Nomad

SERVICE BULLETIN

FLIGHT CONTROLS — FLAPS — CONTROL ROD INSPECTION (MODIFICATION N797)

Figure 1 Flap Control Rod Locations

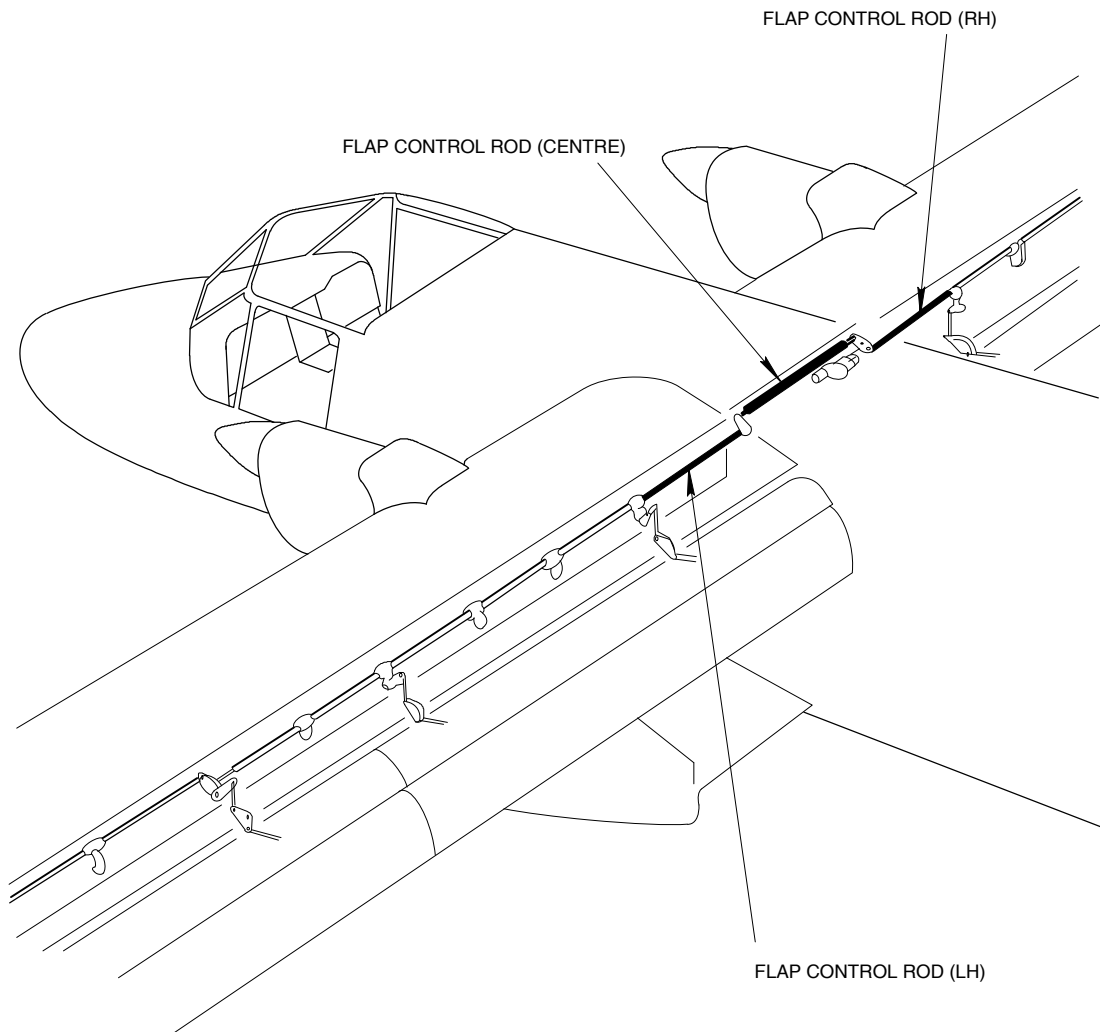
- (2) Make sure aircraft electrical power is switched OFF and the flap circuit breakers are pulled.
- (3) Gain access to flap control rods PN 1/N–45–1138, 1/N–45–1139 and 1/N–45–1140 (Ref Fig 1 and IPC Chap 27–50–02) by removing necessary access panels and trim (Ref MM Chap 27–50–08).
- (4) Inspect the flap control rods and associated components for damage.
- (5) Inspect the control rods for bending using a straight edge along the length of control rod tube.

Maximum bow of the control rod should not be greater than 0.04 in for the control rods 1/N–45–1139 & 1/N–45–1140 and 0.055 in for the control rod 1/N–45–1138.

- (6) Inspect the long end fitting PN 1/N–45–1137 of aluminium alloy flap control rods 1/N–45–1139 and 1/N–45–1140 for evidence of local bending.
- (7) Check the flap control rods for serviceability in accordance with MM Chap 27–00–00 Para 2.C.

- Flap control rods are NOT field repairable units.
- Pre-Mod N797 control rods cannot be replaced individually. All three rods must be replaced with a full set of three Post-Mod N797 control rods regardless of the number of rods found with damage.
- If a Pre-Mod N797 flap control rod is damaged, replace ALL flap control rods with new alloy steel (Post-Mod N797) flap control rods as follows:
